ORBITMASTER WeldHost Software
Version 1.65.3.51

Release Notes

Revision	Date	Description
1	7/31/15	Initial release of 1.65 software (v.1.65.3.48)
2	8/19/15	Update for 1.65.3.51

- Support for Metric Units of Measure (ref #: WH-474).

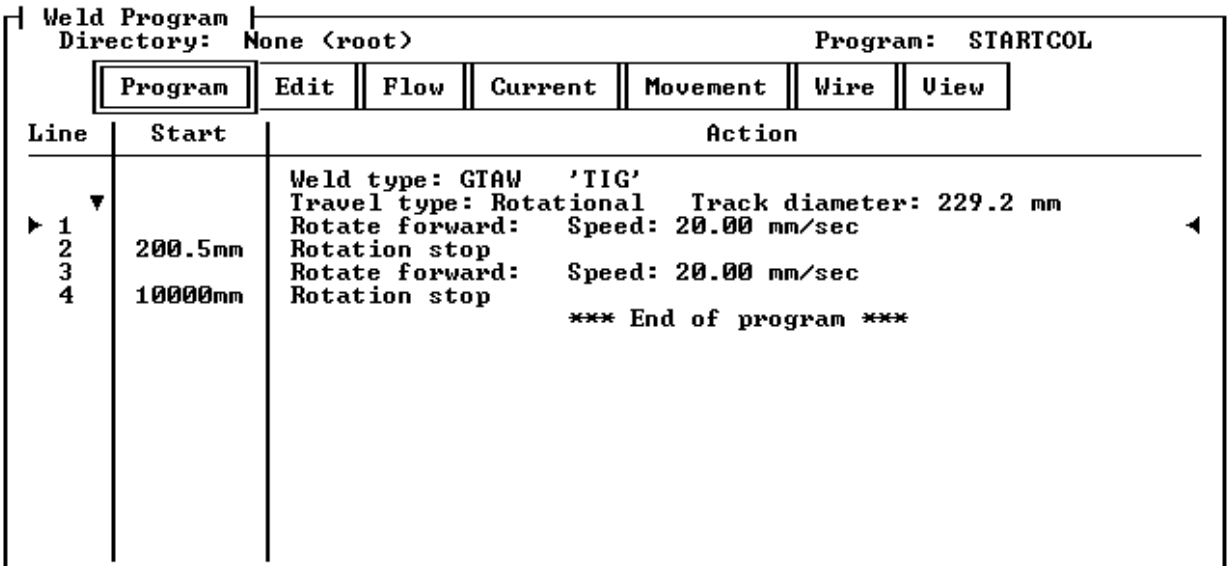
The OrbitMaster welding control console now supports metric units of measure.

Change measurement units from U.S. Customary (default) to Metric from the Setup screen via the System→Measurement unit menu.

Metric measurements are in millimeters (mm) for distance and millimeters per second (mm/sec) for velocity measurements.
